AUSTIN ROVER

Service**BULLETIN**
TECHNICAL

Item 971

fig. 971/1

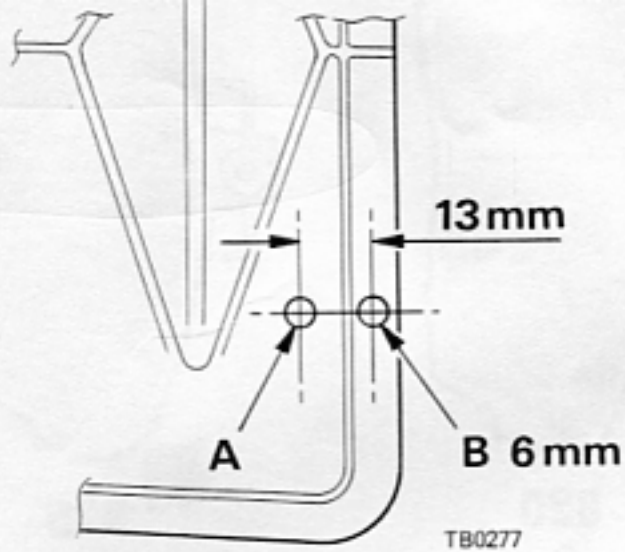
**12. OIL FILTER LEAKING -
DAMAGED BY STONE-GUARD****MONTEGO 2.0 (AUTO)
MAESTRO DIESEL VAN****Problem:** Stone-guard fouling engine oil filter, resulting in oil leak.**Action:** Where this problem is evident, the following action should be taken:

1. Raise and support front of vehicle and turn steering to full right hand lock to allow access to stone-guard.
2. Remove stone-guard (5 fixing screws).
3. Drill new 6 mm hole 'B' in line with existing hole 'A' but in centre of thick surround to stone-guard, as illustrated.
4. Refit stone-guard, using new fixing hole.

fig. 972/1

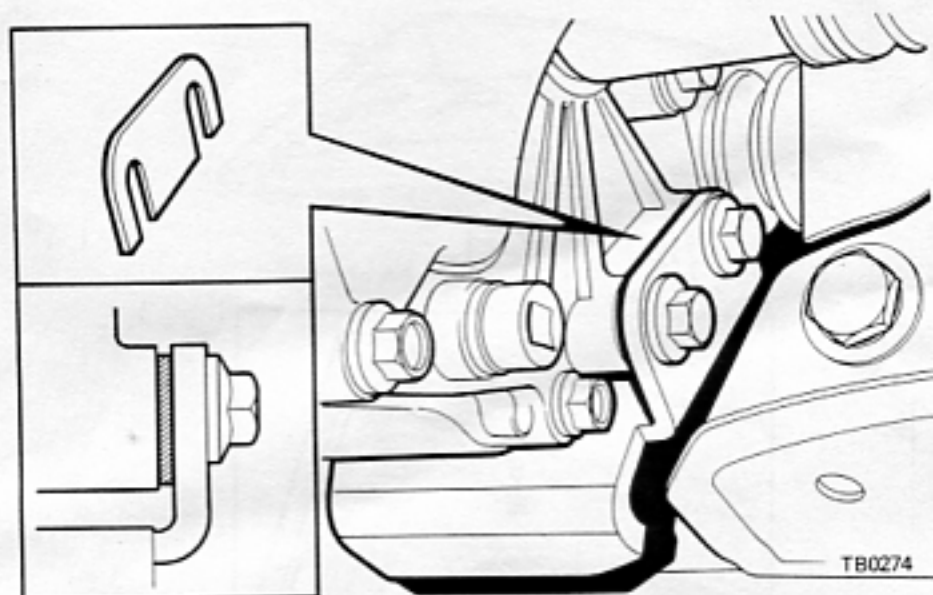
Problem: Oil leak at joint, bell housing to gear case.

Cause: Bracket for rear mounting excessively wide and causing joint faces to be pulled apart as bolts are tightened.

Action: Fit shims, part number ADL 2972, between bracket and transmission case so bracket is firm fit over case. Tighten bolts only to 45 N m.

No more than three shims may be used; should this number be insufficient, a new bracket should be fitted (suitably shimmed, if necessary).

fig. 974/1

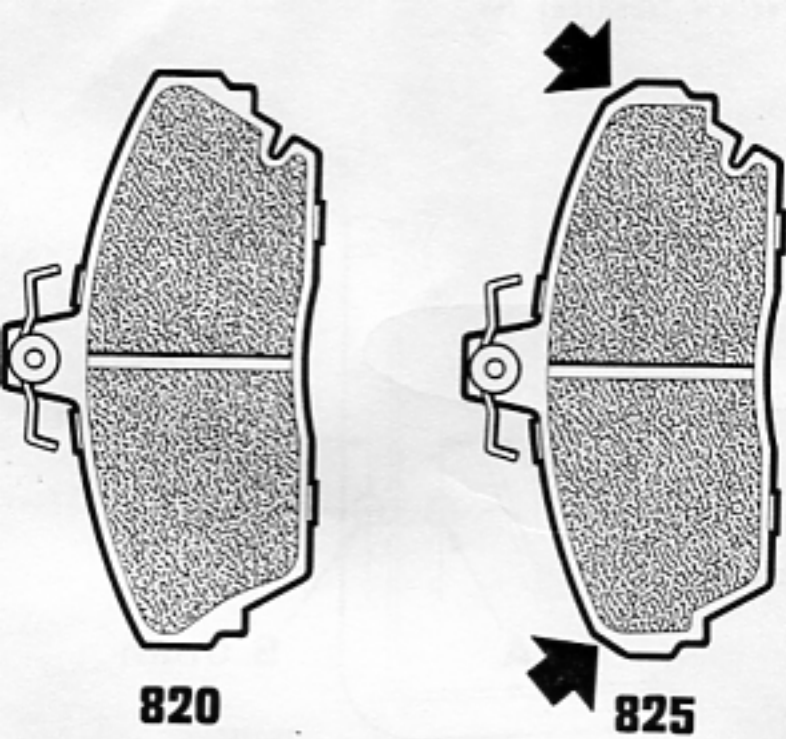
Problem: Water filling space between inner and outer skins of boot lid and thence running into luggage compartment when lid is opened.

Action: Drain holes should be drilled as described below:

- a. open luggage boot and cover bodywork and interior of boot to protect from drilling swarf.
- b. make centre punch mark at two points, one each side, where indicated in illustration, such that edge of 4 mm diameter hole will be close to outer skin of boot.
- c. drill holes 4 mm diameter.
- d. remove any roughness from edge of holes and treat bare metal with zinc-rich primer followed by colour coat.
